Service Bulletin No: 91-001
Modification No: EC-19-0553

**AIR VEHICLE WIRING - GENERAL
IMPROVEMENTS TO THE AIRCRAFT ELECTRICAL HARNESS INSTALLATION**

PC-24 aircraft MSN 101 thru MSN 160.

To improve the electrical harness installation, at various locations throughout the aircraft, to prevent the possibility of the electrical harness chafing on the structure and/or moving parts.

Improvements to the electrical harness installation - Wing fairing
Figure 5 (Sheet 9 of 9)

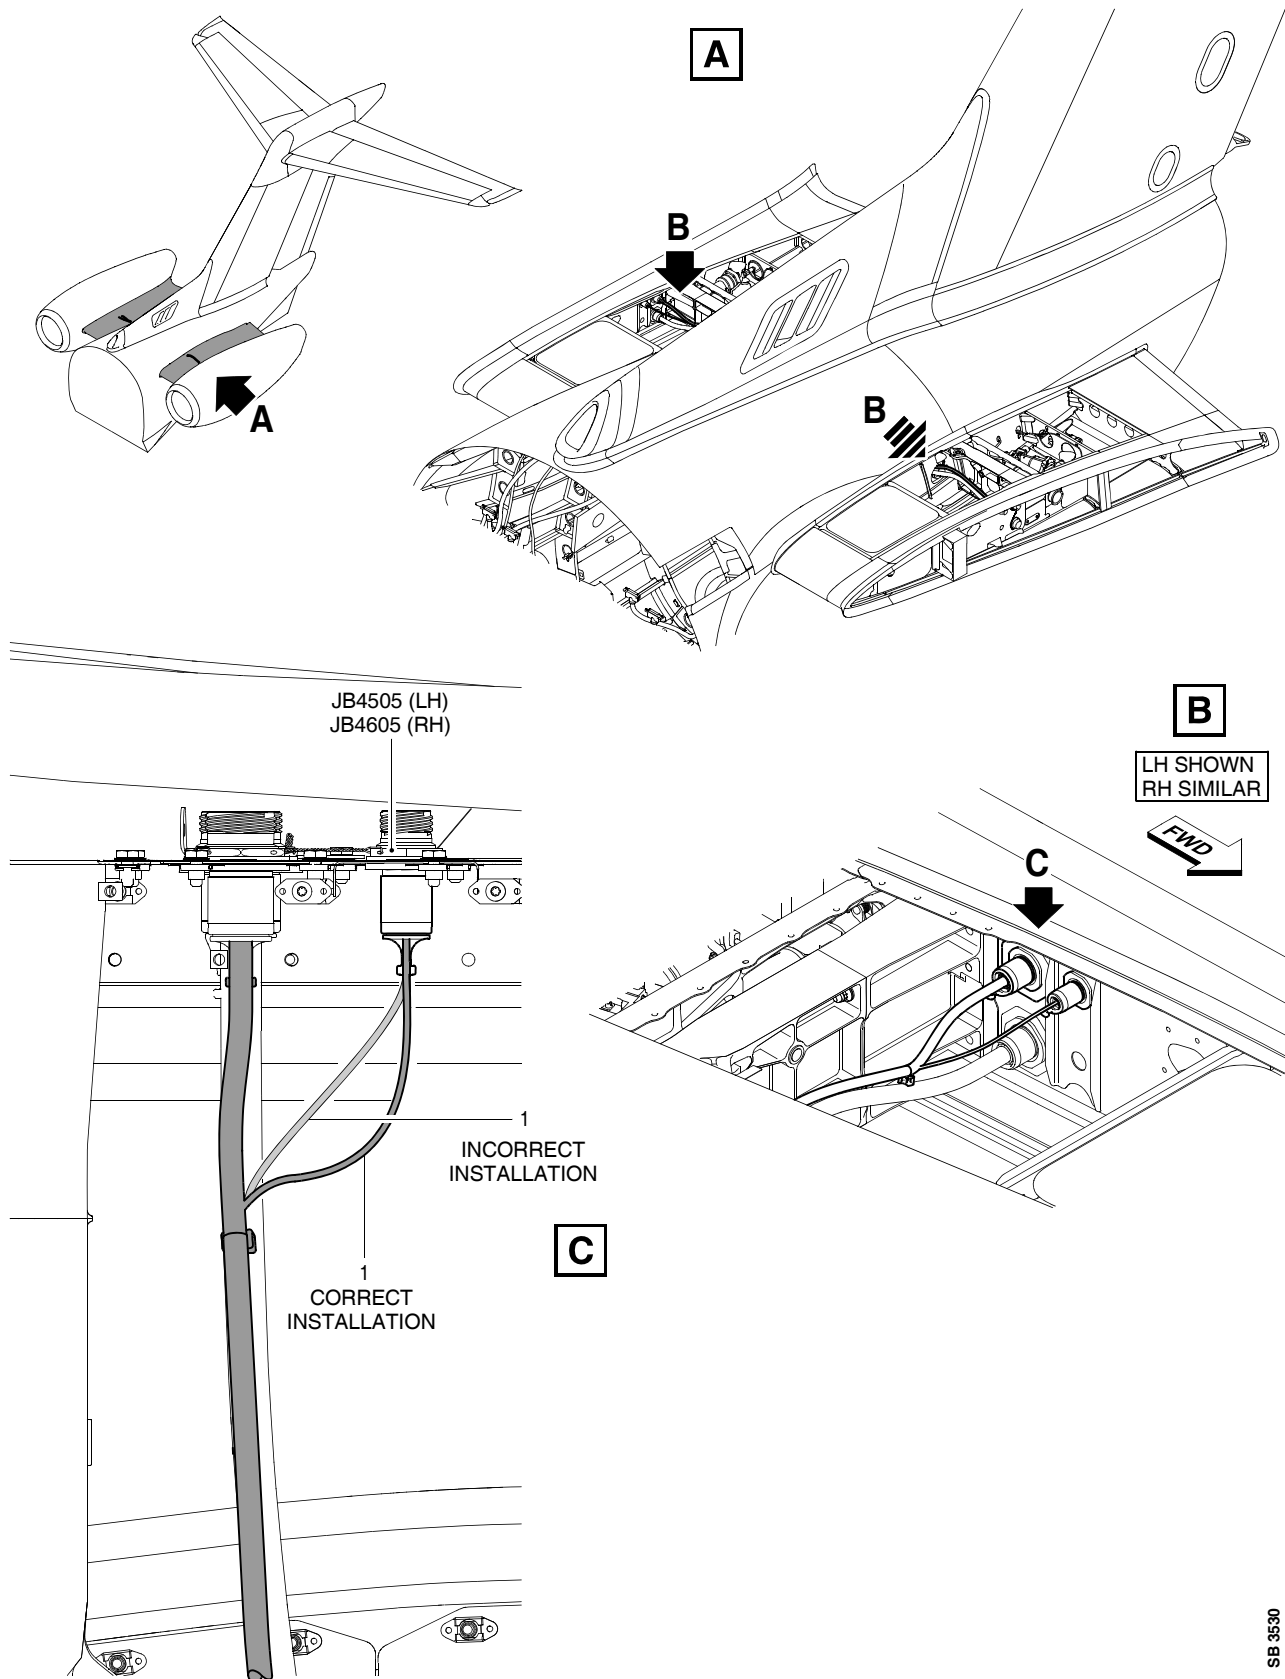
- (5) Improvement to prevent the electrical harness from chafing on the structure.
Refer to Figure 5 (Sheet 9)

NOTE: Refer to Figure 5 (Sheet 9, View J, K and L) to determine the approximate installation position and length of the rubber u-section and the protection sleeve.

- 6 Remove unwanted adhesive with absorbent paper (Material No. P02-031) made moist with solvent (Material No. P01-010).
- (b) Install the protection sleeve on the electrical harness:
- 1 Cut and remove the necessary cable ties from the electrical harness (23) to get sufficient access to install the new protection sleeve (22).
 - 2 Cut a new piece of protection sleeve (22) (P/N 917.96.92.152) to a length of 1.97 in (50,00 mm).
 - 3 Put the new protection sleeve (22) in position on the electrical harness (23) below the structure angle (21) and the rubber u-section (20) that you installed.
 - 4 Use the applicable new cable ties (Material No. P09-005/P09-008/P09-014) to:
 - Attach the protection sleeve (22) to the electrical harness (23)
 - Replace any cable ties that you cut and removed to get access.
